ADDENDUM

ADDENDUM NO.: 01
PROJECT NAME: Sheridan Elementary School Annex
PROJECT NO.: 05075
CONTRACT NO.: C1581
DATE OF ISSUE: September 1, 2017

NOTICE OF CHANGES, MODIFICATIONS, OR CLARIFICATIONS TO CONTRACT DOCUMENTS

TITLE:
ROOF CONSTRUCTION PLAN

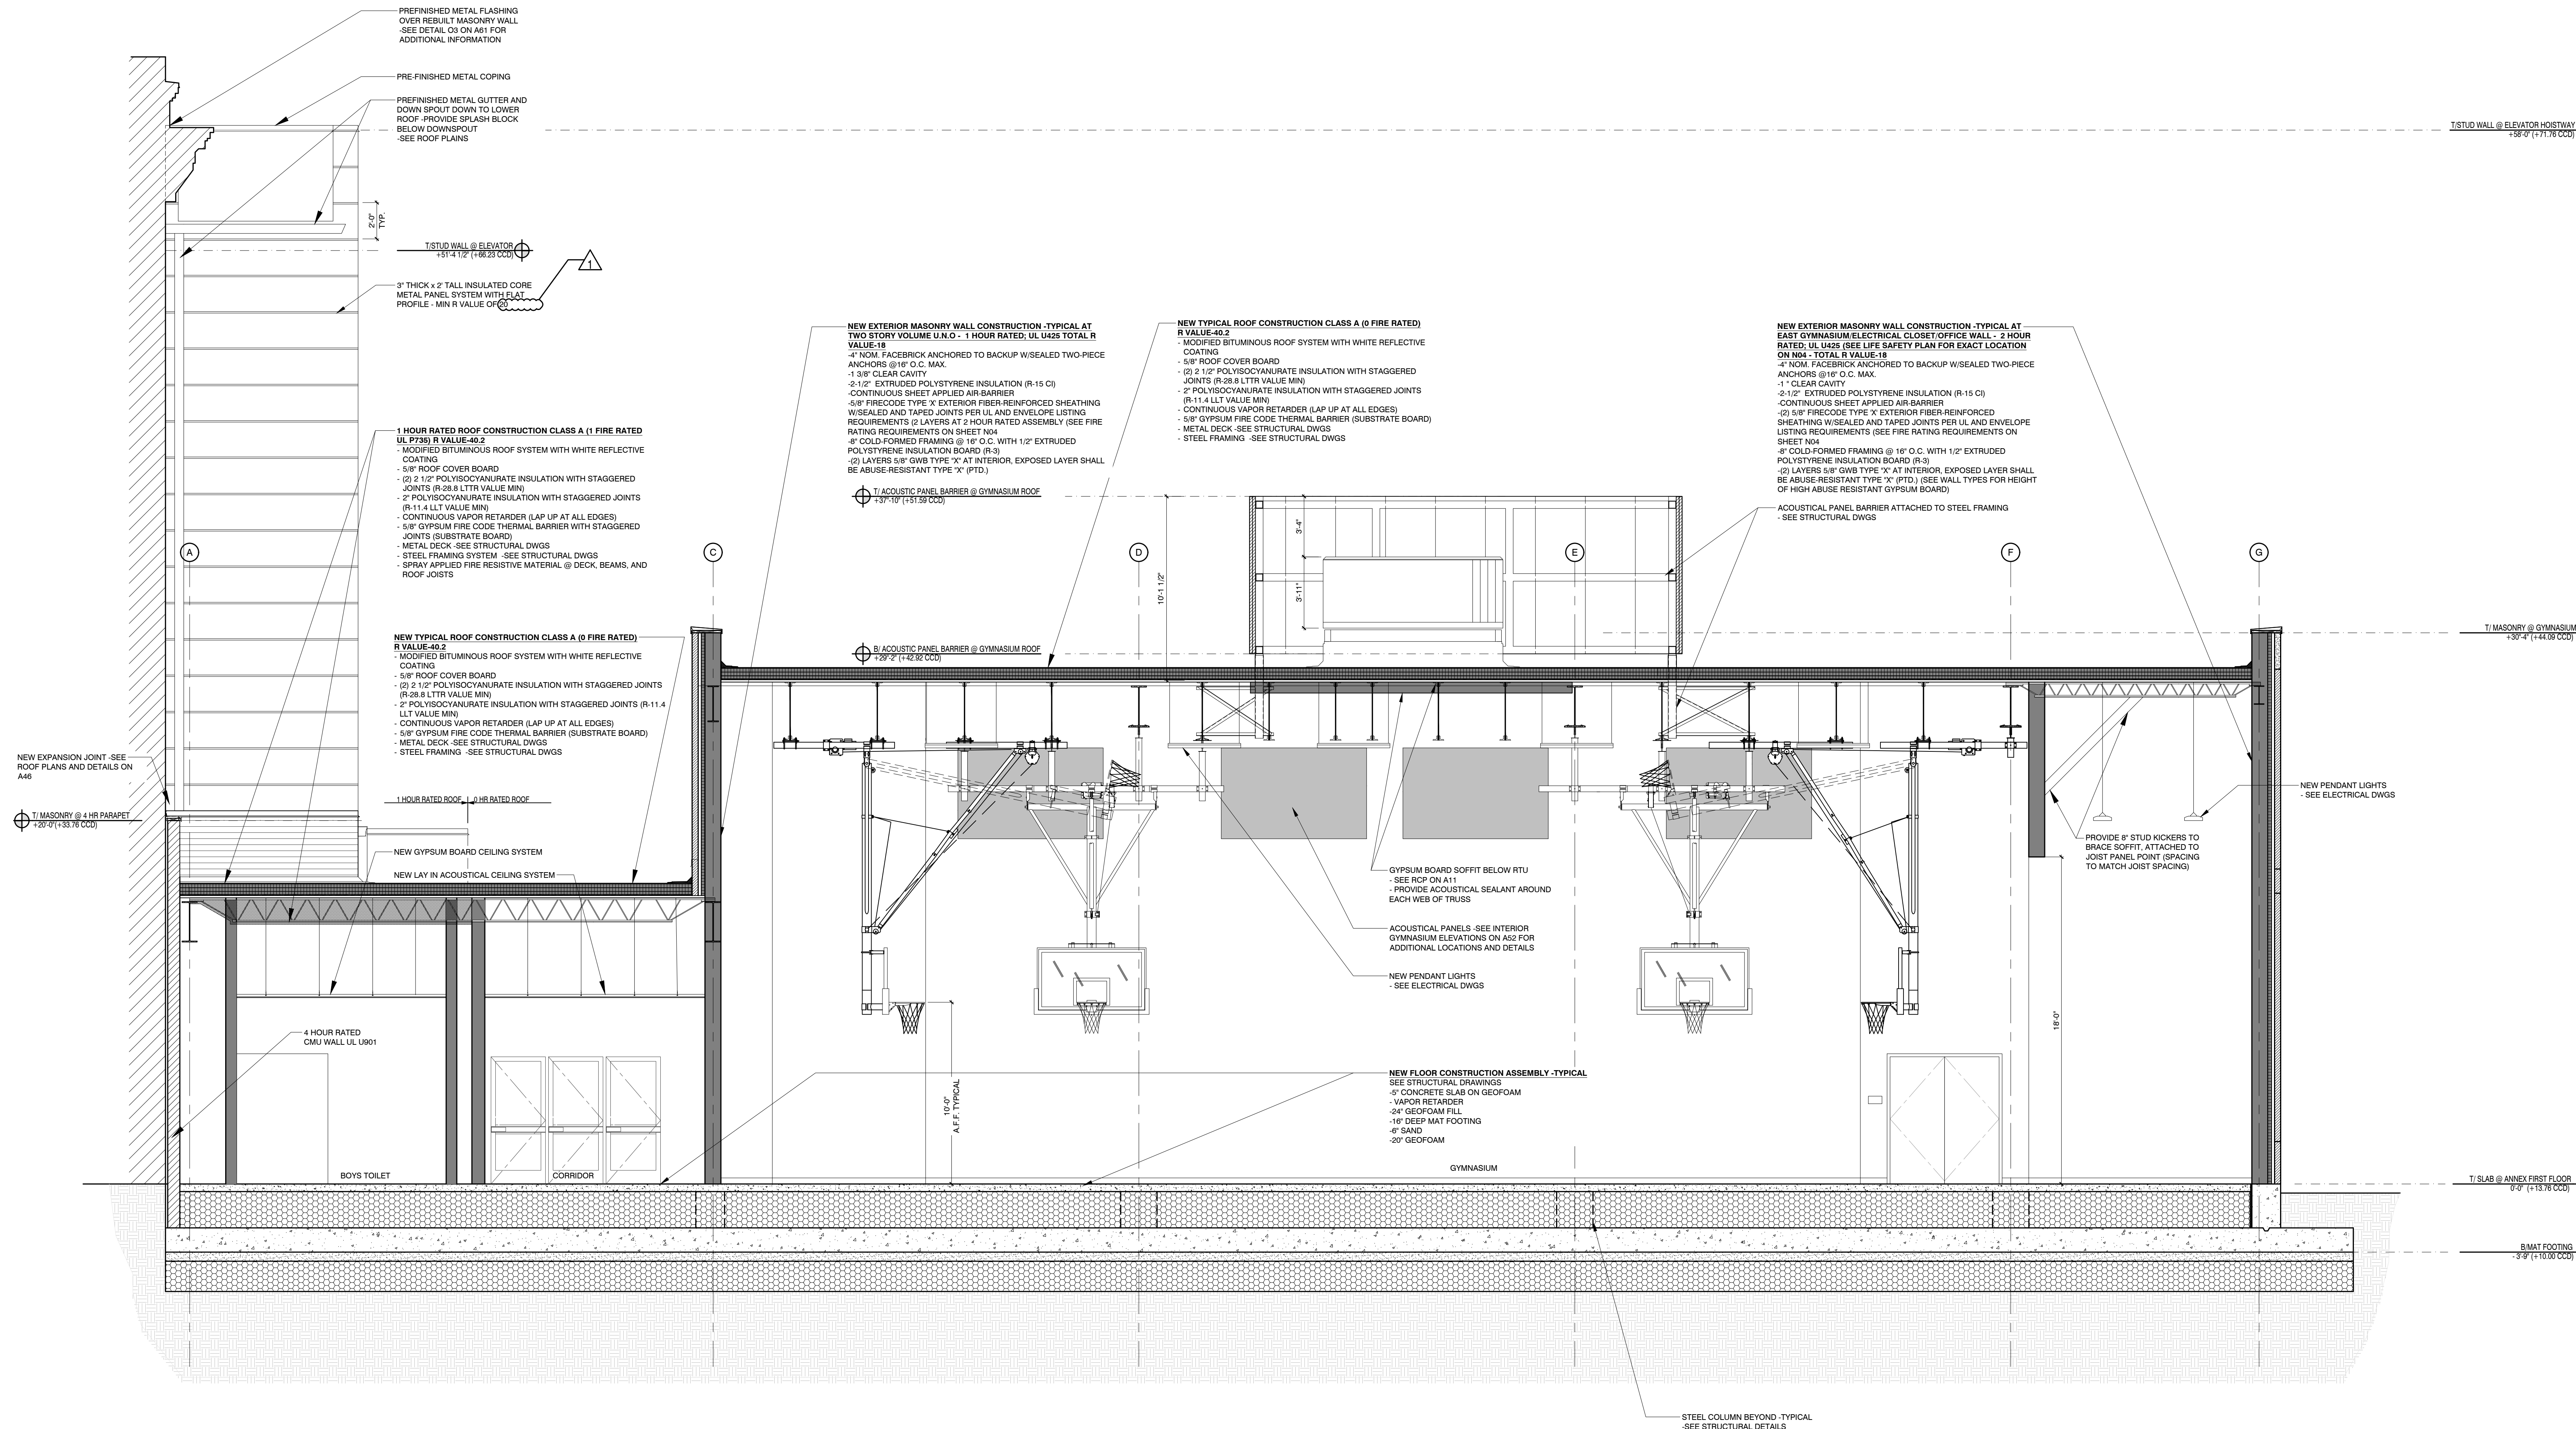
Change 4. REVISED – Drawing No. A04 – ROOF CONSTRUCTION PLAN: Added Expansion joint reference plan 02/A04
